To: North Ventura Coordinated Area Plan <a href="https://www.nvcape.com/nvcap

Dear Mayor Fine and Palo Alto City Council Members and the NVCAP Working Group,

At the meeting in which the Working Group meets to consider alternatives, I ask that you consider these points:

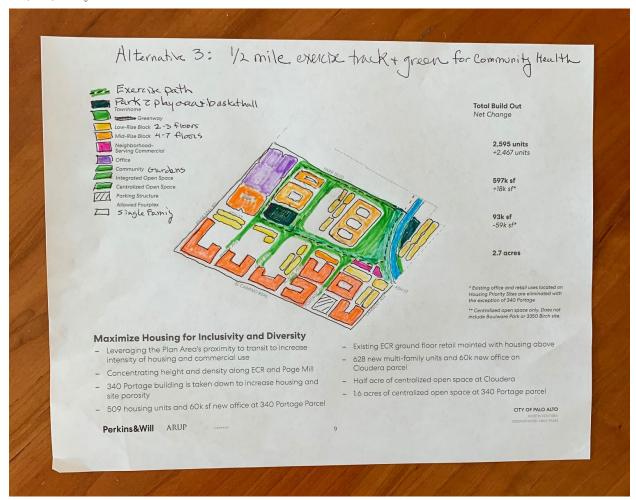
We enjoyed being able to attend the NVCAP working group meeting last week.

After listening to the discussions we would like to submit these plan ideas that prioritize community, health, as well as residential capacity. Residential density is focused peripherally and a greenfield, park, community gardens and 1/2 mile exercise path are central.
